Private Plan Change 23: Whisper Creek,
Spencerville to the Christchurch City Plan.

STATEMENT OF PRIMARY EVIDENCE OF
MICHAEL GRANT SMITH

OURUHIA RESIDENTS GROUP

Figure 1 – Spencerville area road Hierarchy (extracted from the CCC District Plan)

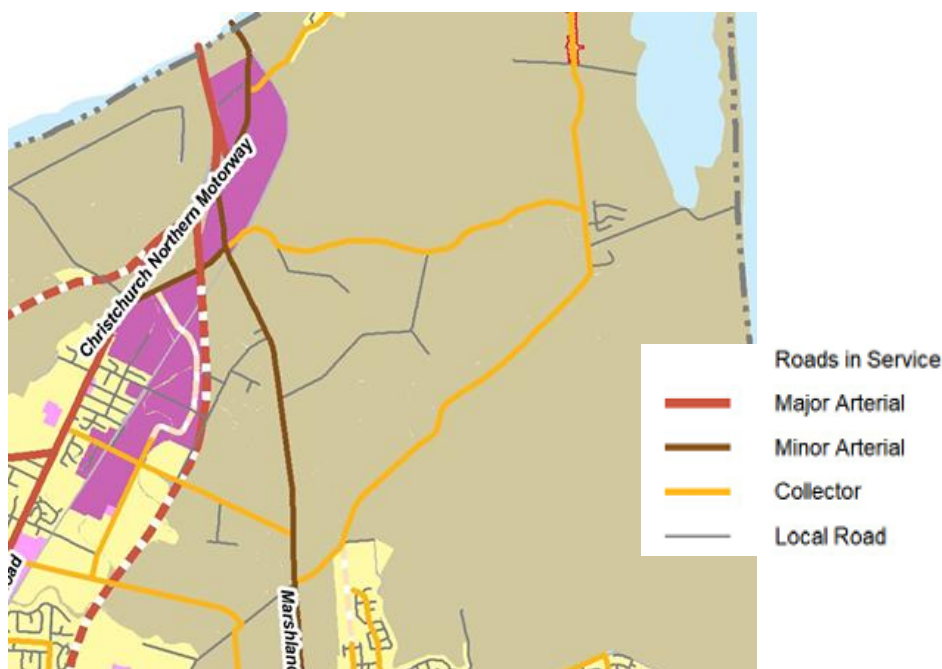
16. At that time (2010) Lower Styx Road was classified as a Minor Arterial Road, Spencerville as a collector Road, and Marshland Road as a Major Arterial Road. Since the opening of the Christchurch Northern Corridor motorway in December 2020, Marshland Road was downgraded to a Minor Arterial, and Lower Styx Road to a Collector – presumably in recognition of the relatively low traffic flows expected with the golf course zoning. Figure 1 shows the current Road hierarchy on the area.

19. A rural local road is expected to carry less than 250vpd, a rural collector between 100 and 2,500vpd, and a minor arterial between 2,000 and 12,000vpd. Currently, as far as I can tell from the documents, Marshland Road is carrying around 8,200vpd, Lower Styx 1600-2000vpd, Spencerville 500 to 1000vpd, and Turners 220-800¹vpd, meaning that all are operating with expected levels.
20. Hierarchies are included in District Plans for a reason. They exist to give residents confidence in the likely future operation of their surrounding network. In my view, residents

Figure 3 – Crash locations 2021-2026 (from NZTA open data portal)

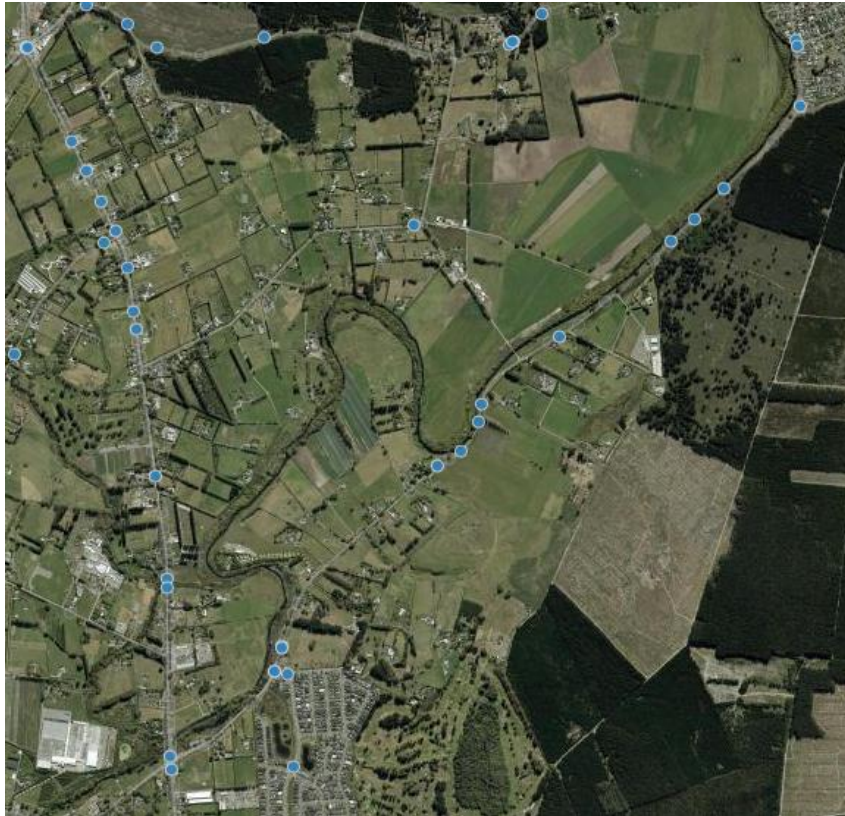
The ITA has identified 24 crashes between 2020 and 2025, of which only 5 involved minor injuries, with no fatalities and no serious injury crashes. I have looked at crash data (as shown in Figure 3) from 2021-2026 and have identified three serious crashes in 2025 – one on Marshland near Turners, one the Turners/ Teapes corner, and one on Spencerville Road near Farrells. Anecdotally, the residents note that there have been several more crashes at the Turners/Teapes corner that have gone unreported. This is a relatively high rate given the very low traffic flow on Turners Road. In addition, there were fourteen minor injury crashes in the period with six on Marshland, five on Spencerville (with one at the rail crossing) and three on Lower Styx Road. There were also 18 non-injury crashes. Accordingly, the ITA may be giving a misleading picture.

23. If the Commissioner is minded to approve the Plan Change, then I would suggest that a road safety audit is carried out at each stage of the project – namely consenting, detailed design, construction and post construction.
